PRODUCT CHANGE NOTIFICATION

PCN No.: PCN-202610-002	**PCN Doc No.:** EC-20261008-PCN-01	**Date Issued:**	10/8/2026
Part Number or Series: MTJG-2-88JX1-V-FSG-L36-M268Y		**PCN Effective Date:**	10/8/2026
Customer: (If applicable)		**P/O No.: (If applicable)**	Not affected
Type of Change:	■ Design Change / Data Sheet Spec Change	**Last Time Buy Date:**	Not affected
Traceability Marking/Date code:	No change	**Last Time Ship Date:**	Not affected
Replacement Part Number:		**Sample Availability Date:**	Not affected

Change Description: New mold production, optimizing the structure of plastic and hardware molds;

Before Change

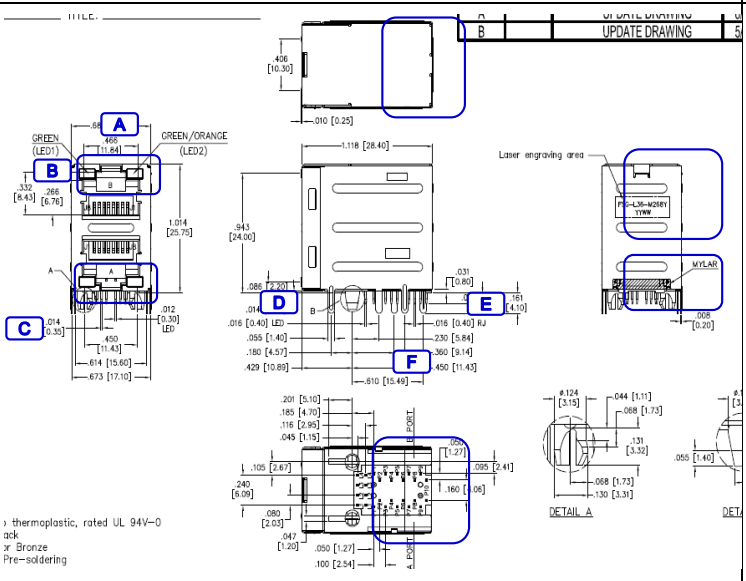
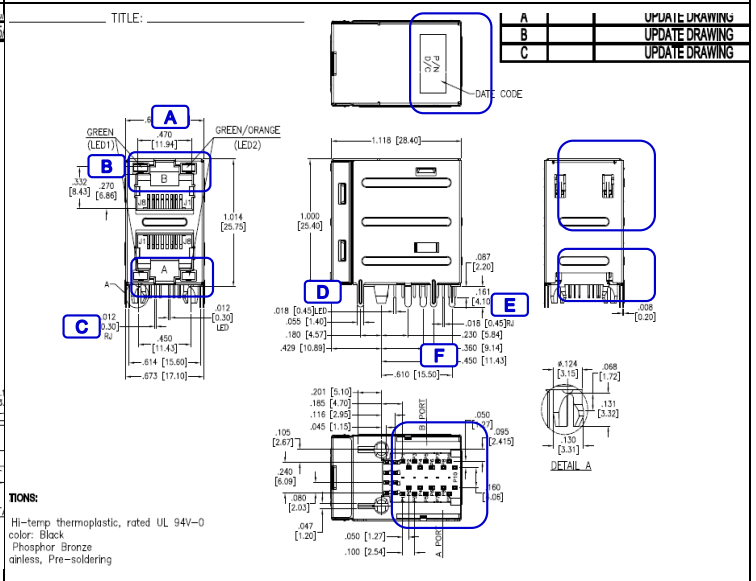
Impact of Change: The function remains unchanged, but there are slight differences in appearance and size;

Before the change:
1、Appearance ~ As shown in the above picture;
2、Size:
A) 11.84mm B) 6.76mm C) 0.35mm
D) 0.40mm E) 0.40mm F) 15.49mm

After the change:
1、Appearance ~ As shown in the above picture;
2、Size:
A) 11.94mm B) 6.86mm C) 0.30mm
D) 0.45mm E) 0.45mm F) 15.50mm
